J AND K MODULE FOR PROPORTIONAL TYPE

Size B	Document Number STC1000F.SCH	Rev 00
Date:	Sunday, August 24, 2003	Sheet 1 of 1

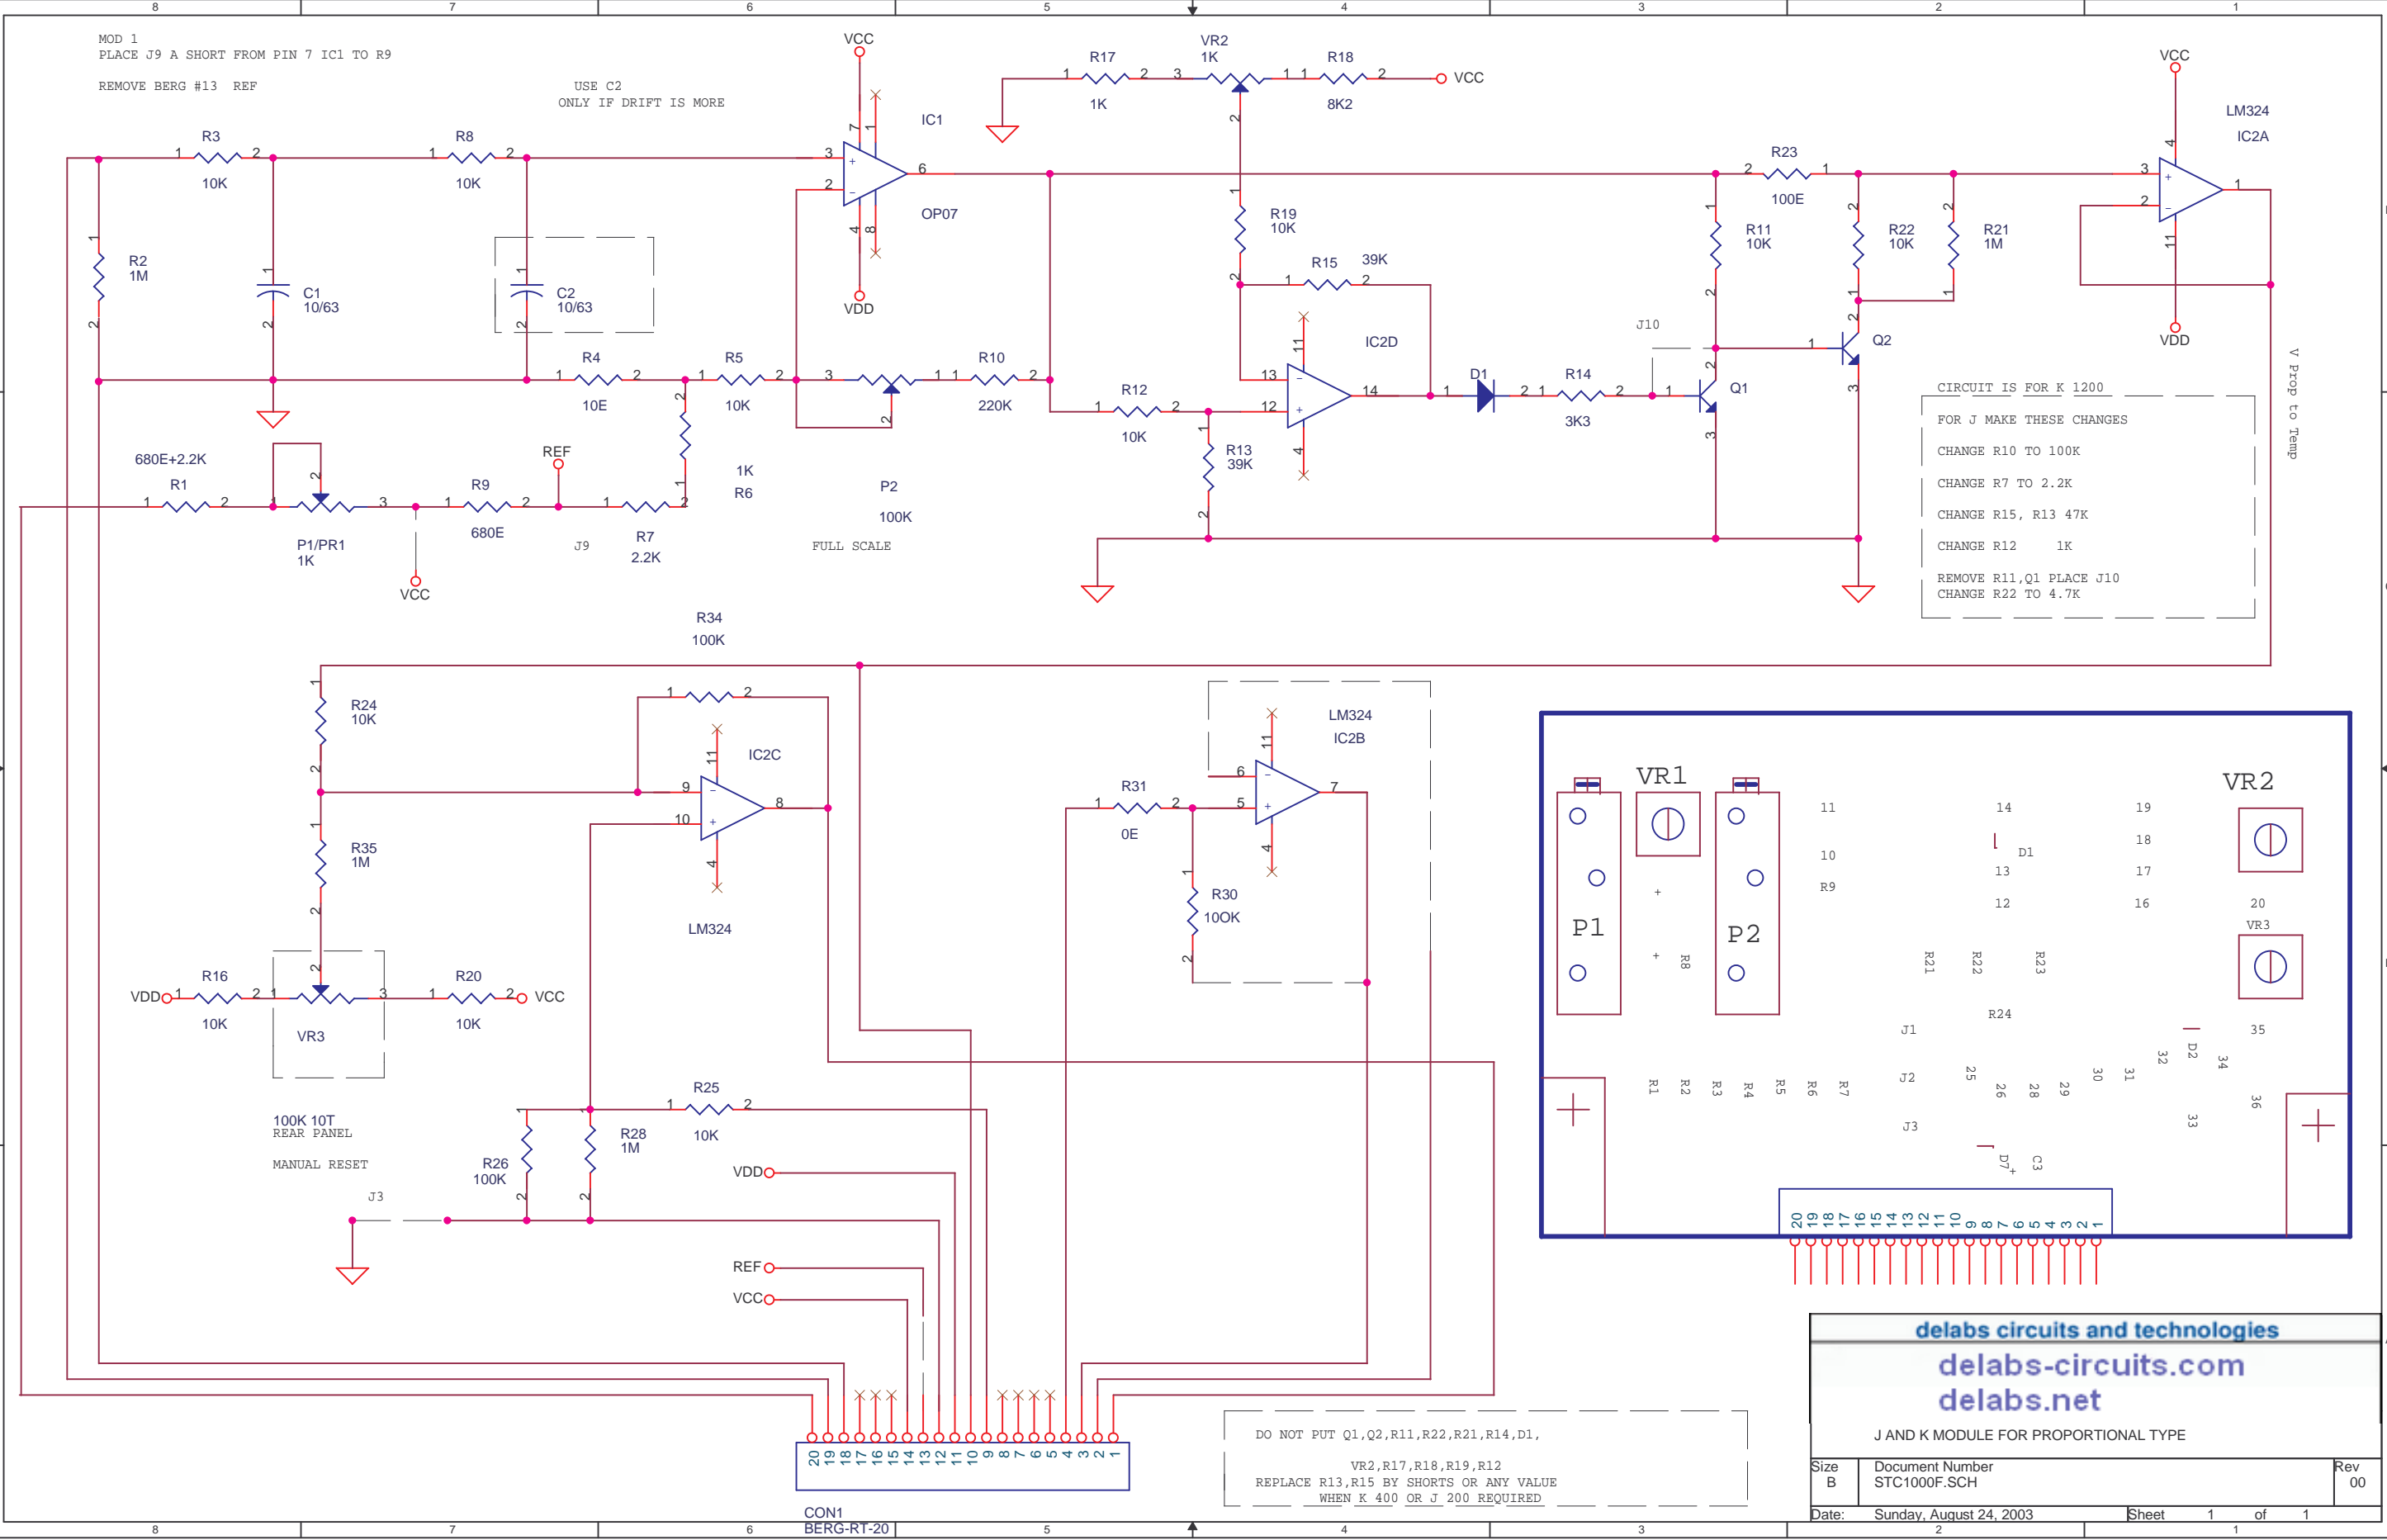
MOD 1
PLACE J9 A SHORT FROM PIN 7 IC1 TO R9
REMOVE BERG #13 REF

USE C2
ONLY IF DRIFT IS MORE

CIRCUIT IS FOR K 1200
FOR J MAKE THESE CHANGES
CHANGE R10 TO 100K
CHANGE R7 TO 2.2K
CHANGE R15, R13 47K
CHANGE R12 1K
REMOVE R11,Q1 PLACE J10
CHANGE R22 TO 4.7K

DO NOT PUT Q1,Q2,R11,R22,R21,R14,D1,
VR2,R17,R18,R19,R12
REPLACE R13,R15 BY SHORTS OR ANY VALUE
WHEN K 400 OR J 200 REQUIRED
